DEVELOPMENT ASSESSMENT REPORT	
Application No.	MOD/2020/0378
Address	89 Balmain Road LEICHHARDT NSW 2040
Proposal	Application under Section 4.55(2) of the Environmental Planning and Assessment Act 1979 to modify Determination No D/2019/25 dated 8 October 2018 to carry out various internal and external changes, including internal design and layout changes, deletion of car stackers, and reduction in building height of the approved boarding house
Date of Lodgement	2 November 2020
Applicant	Habitation Design
Owner	Billionga Holdings Pty Ltd
Number of Submissions	Initial: 2 After Renotification: Nil
Value of works	\$1,078,930.00
Reason for determination at Planning Panel	Changes (reflecting deletion of car stackers) to Conditions 5 and 61(q) imposed by the Panel
Main Issues	Building siting and design; Parking
Recommendation	Approved with Conditions
Attachment A	Recommended and amended conditions of consent

1. Executive Summary

This report is an assessment of the application to modify a consent submitted to Council under Section 4.55(2) of the Environmental Planning and Assessment Act 1979 seeking to modify Development Consent D/2019/25 dated 8 October 2018 to carry out various interna

SCALE @ A1:	1:100
SCALE @ A2:	1:200
DRAWN BY:	HJK
CHECKED BY:	JLP
PROJECT NUMBER:	18093
SHEET NUMBER:	G106

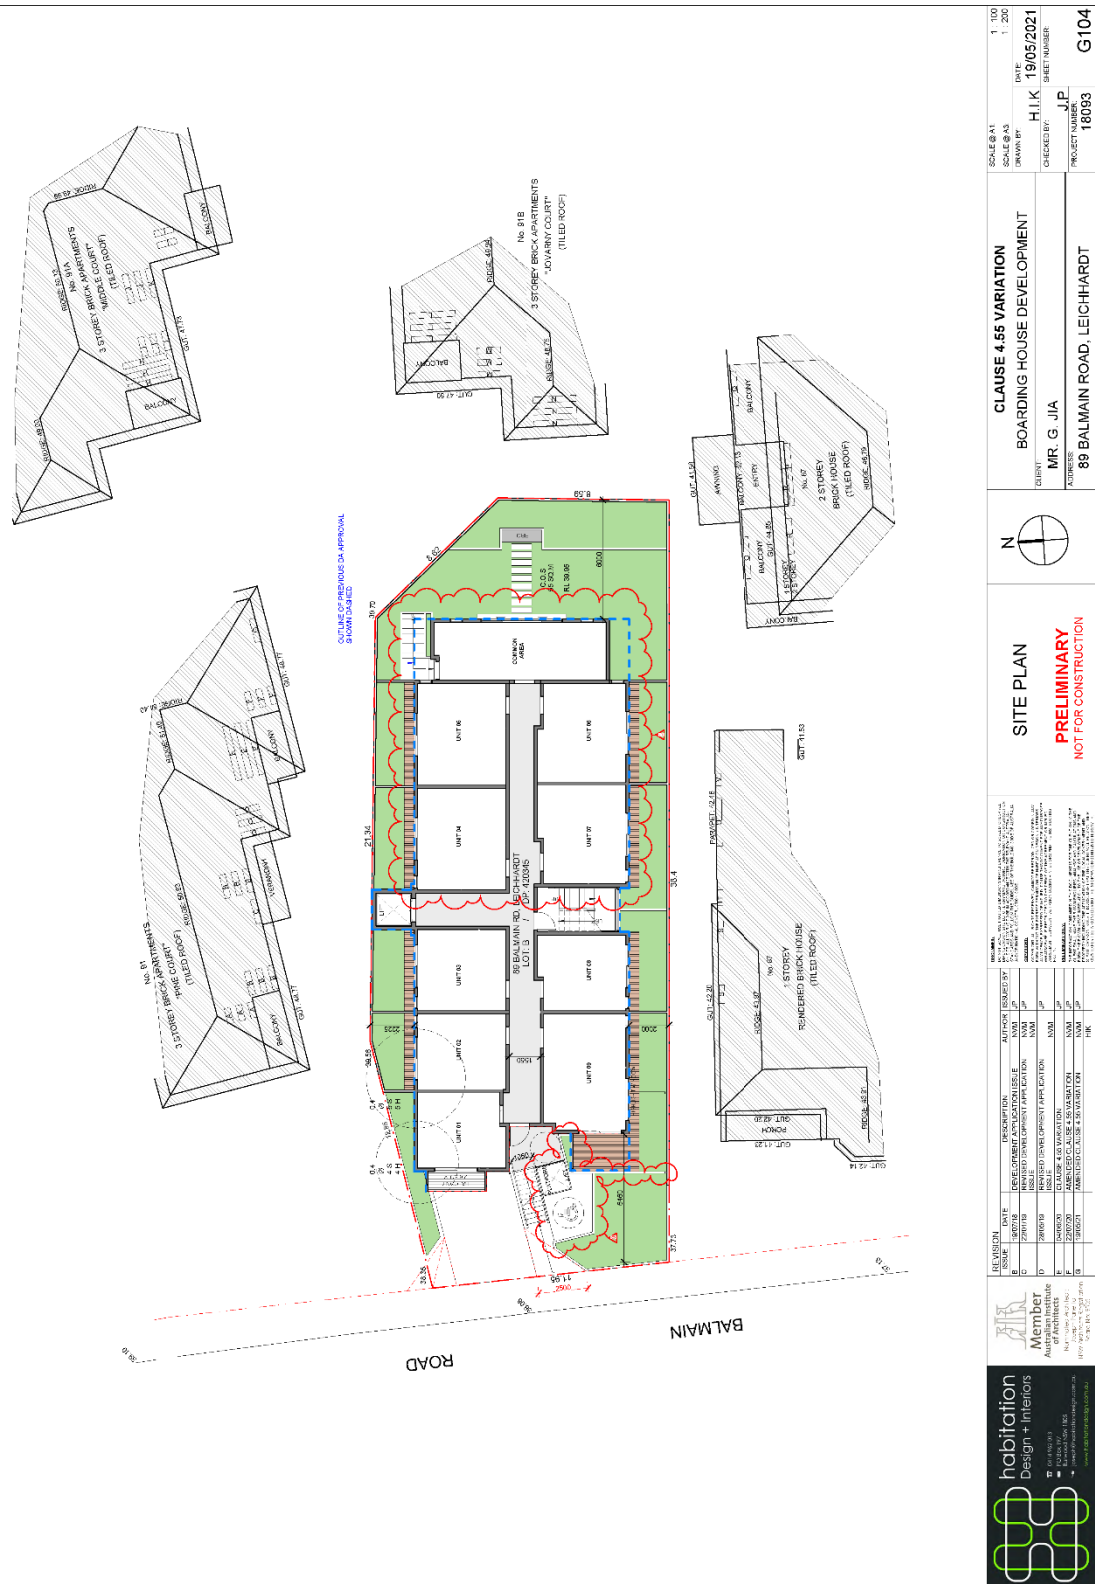
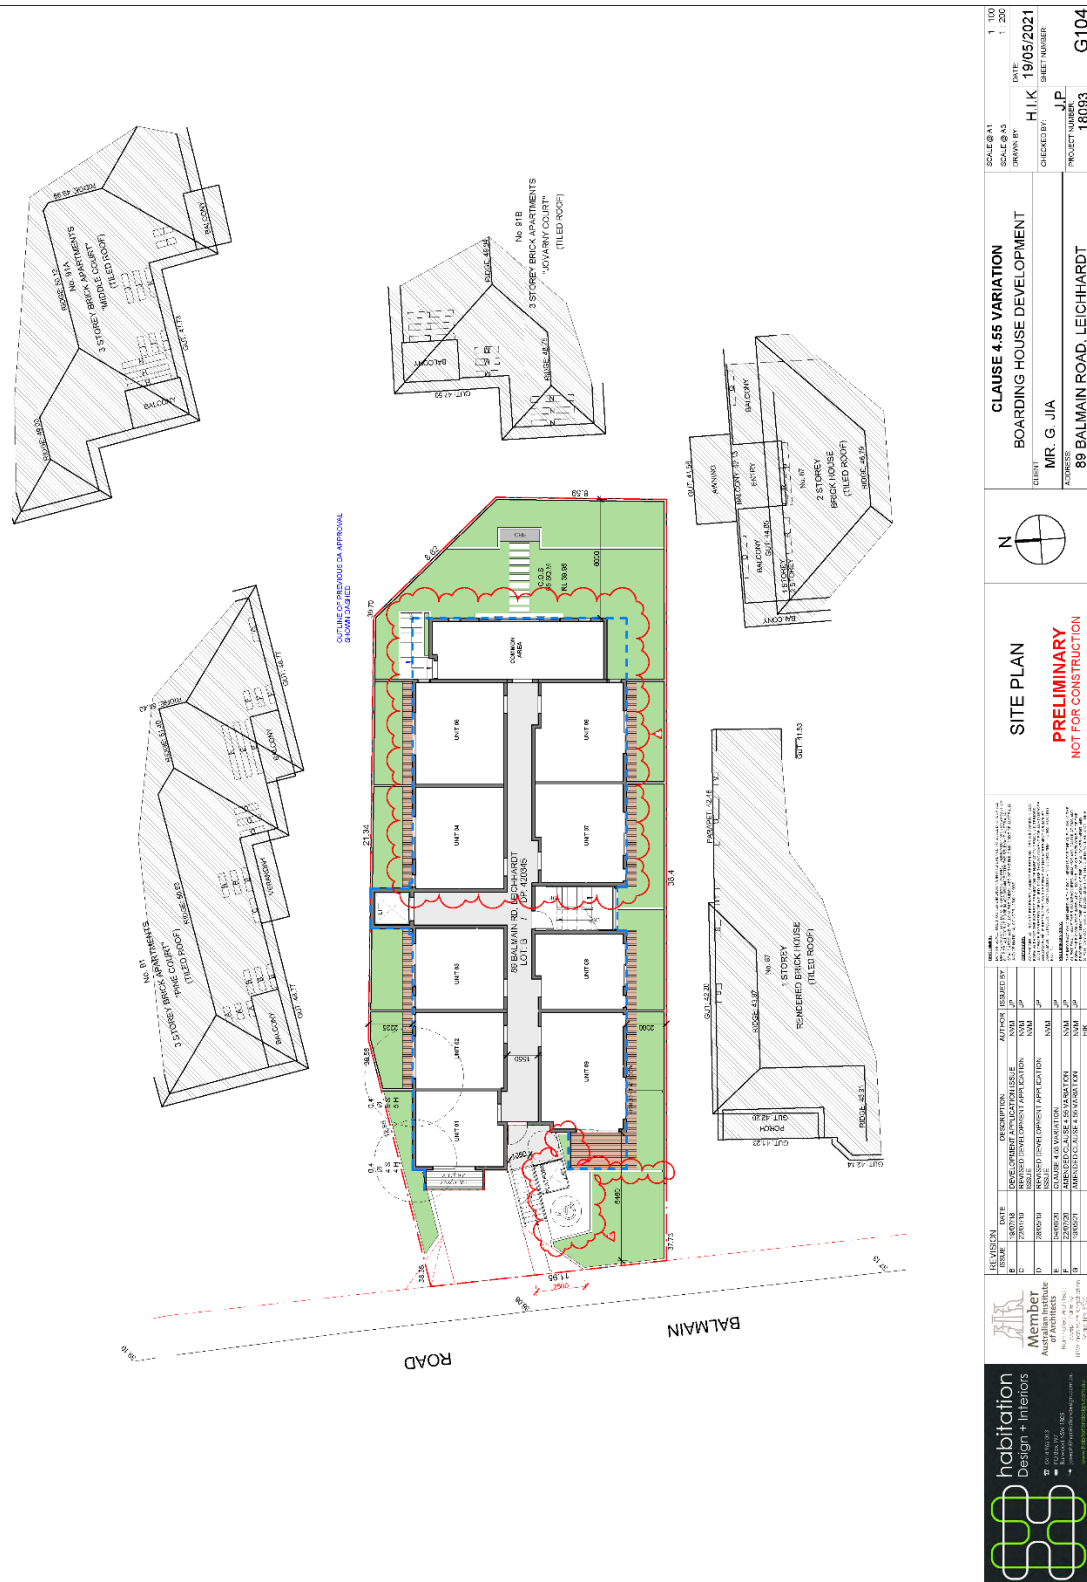
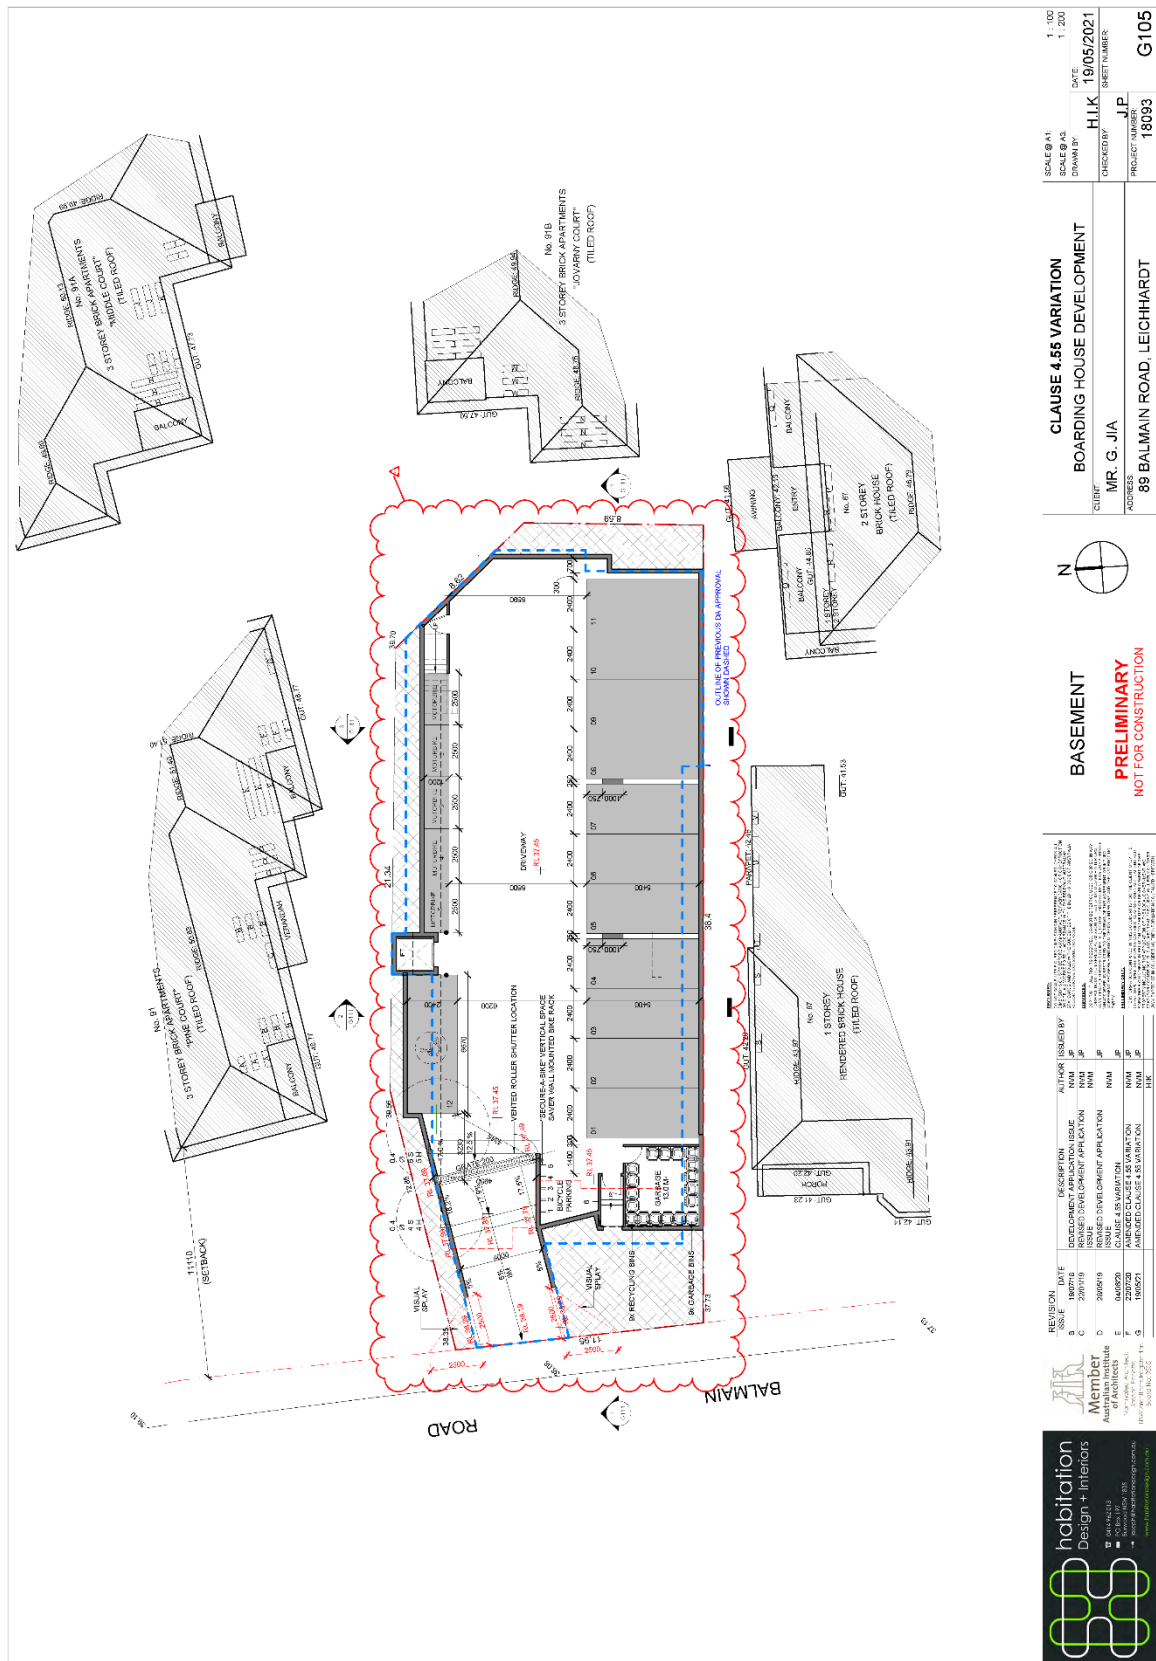
1. ***Redesign of Basement parking including removal of stack parking spaces and slight relocation / offset of the lift location from the Northern boundary***
2. ***Redesign of Rooms 4,5,6,7 and Common Area***
3. ***Reduction in GFA for Room 19.***
4. ***Reduction of Building height by 300mm.***

In response to Council's concerns raised in relation to the proposed reduction in car parking from 12 to 10 spaces, amended plans were provided with a reconfigured basement parking layout to maintain the required 12 car spaces.

No objections to the proposed revised basement floor layout, which shows 12 parking spaces (without car stackers), 5 motorcycle spaces and 6 bicycle spaces. The following conditions are to be deleted given car stackers are no longer proposed:
 - Condition 36(e)

Accordingly, it is proposed to update Condition 4 to reflect the updated plans, delete Condition 5(1), (2), (3) and (4) and update various conditions to remove reference to car stackers.
